## DEVELOPMENT APPLICATION ASSESSMENT REPORT

<b>Application Number:</b>	DA2023/0191
----------------------------	-------------

<b>Responsible Officer:</b>	Jordan Howard
<b>Land to be developed (Address):</b>	Lot 19 DP 28394, 19 Moresby Place ALLAMBIE HEIGHTS NSW 2100
<b>Proposed Development:</b>	Demolition works and construction of a dwelling house
<b>Zoning:</b>	Warringah LEP2011 - Land zoned R2 Low Density Residential
<b>Development Permissible:</b>	Yes
<b>Existing Use Rights:</b>	No
<b>Consent Authority:</b>	Northern Beaches Council
<b>Land and Environment Court Action:</b>	No
<b>Owner:</b>	Richard David Merry Laura Anne Marie Merry
<b>Applicant:</b>	Mark Wills

(Figure 1 - Eastern Elevation with side boundary envelope encroachment in red)

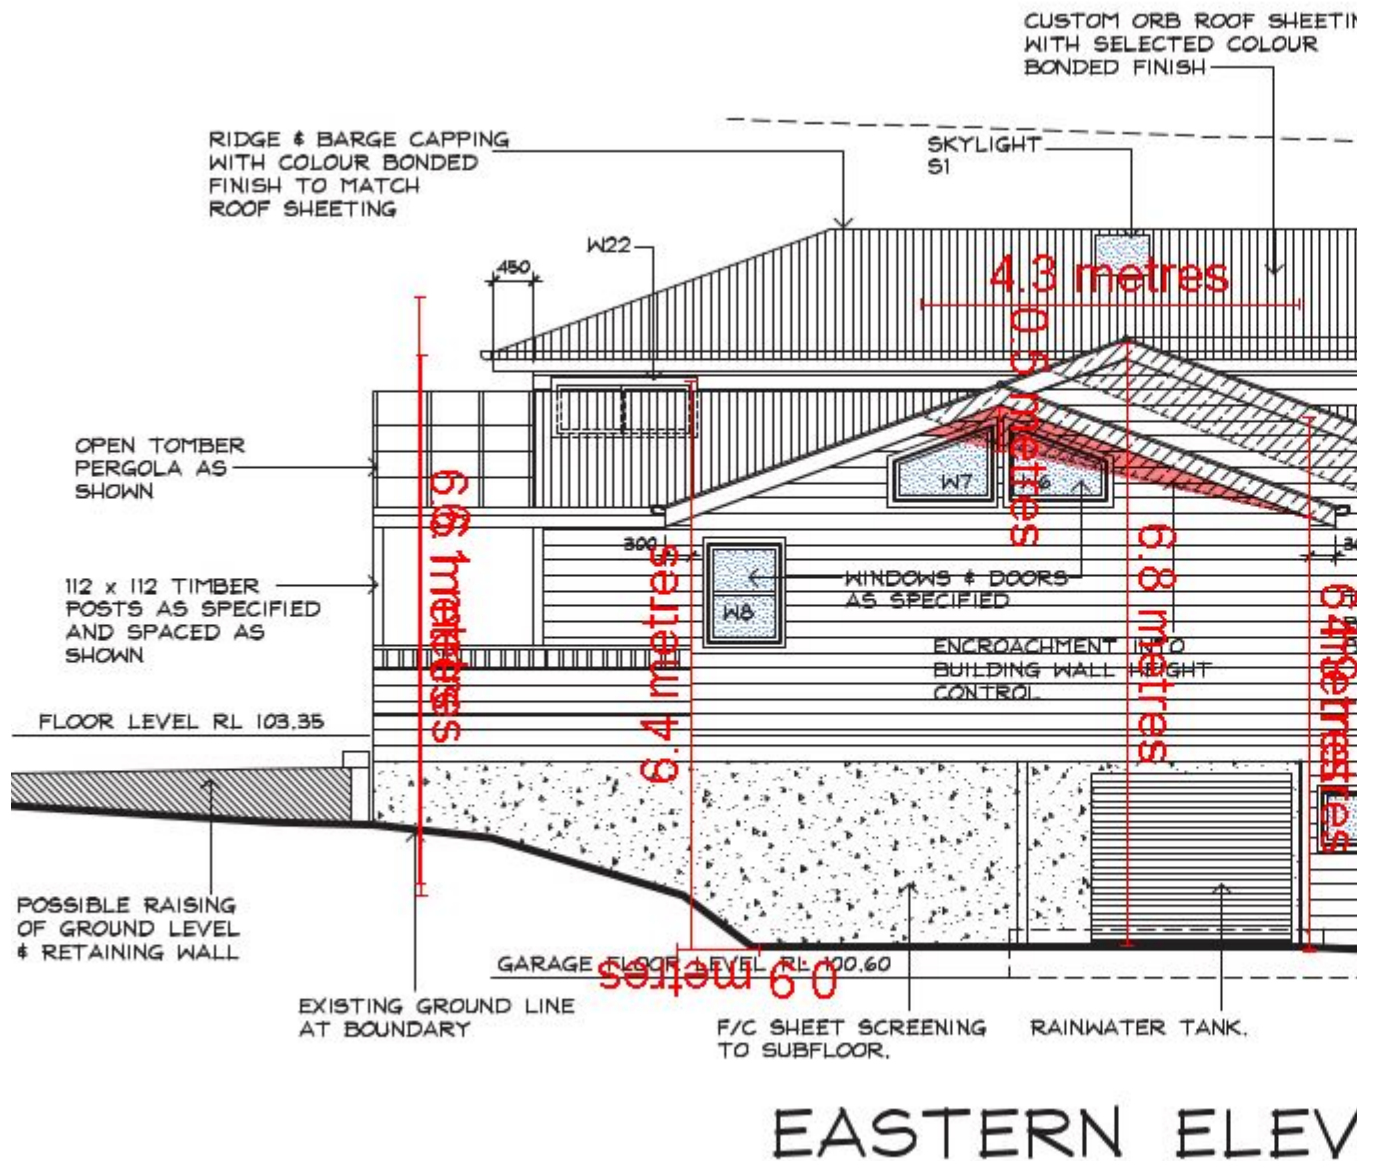
The proposed development encroaches the side building envelope on the eastern elevation as depicted in *Figure 1*. The breach runs for a horizontal length of 4.3m on eastern most wall of the kitchen, and has a maximum vertical height of 0.5m.

*(Figure 2 - Western Elevation with side boundary envelope encroachment in red)*

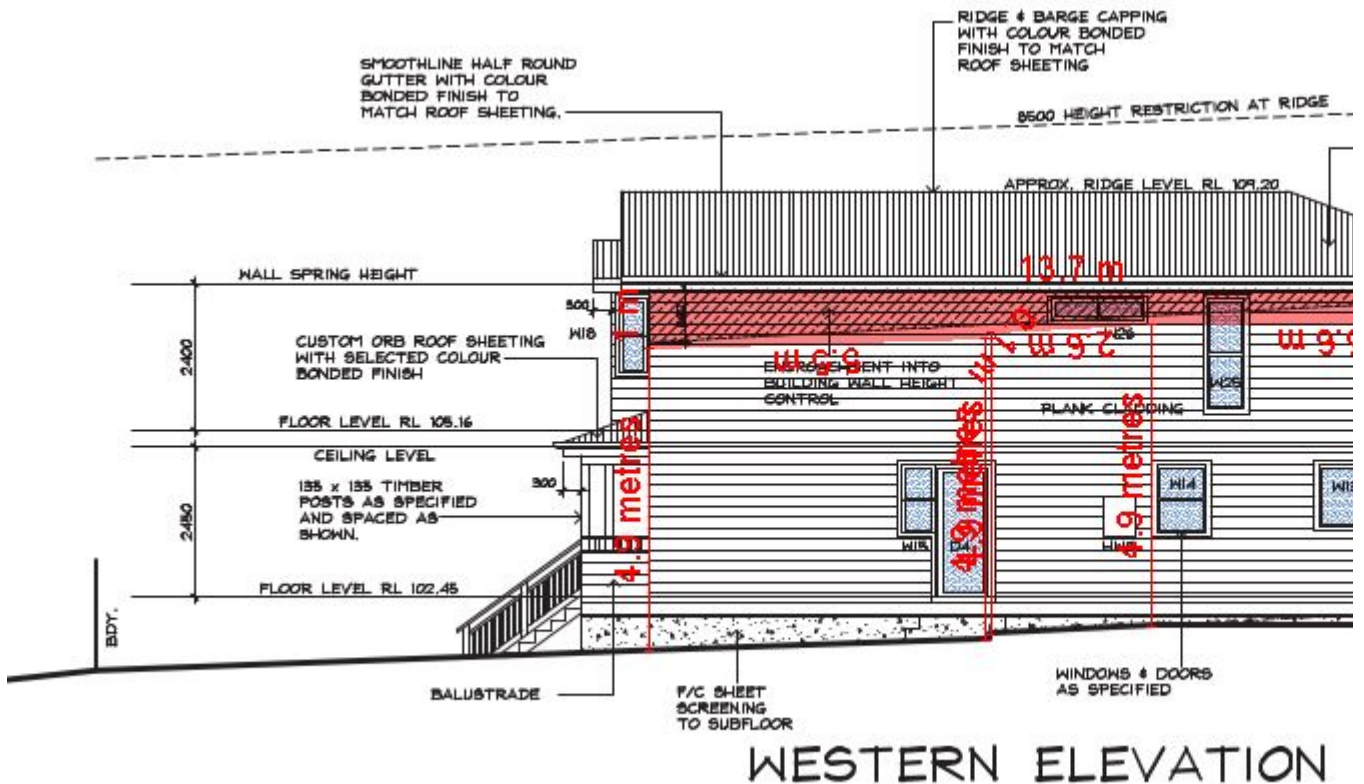
The proposed development encroaches the side building envelope on the western elevation as depicted in *Figure 2*. The breach runs for a horizontal length of 13.7m from the front to the rear of the proposed dwelling and has maximum vertical height of 1m at the northern end of the western elevation.
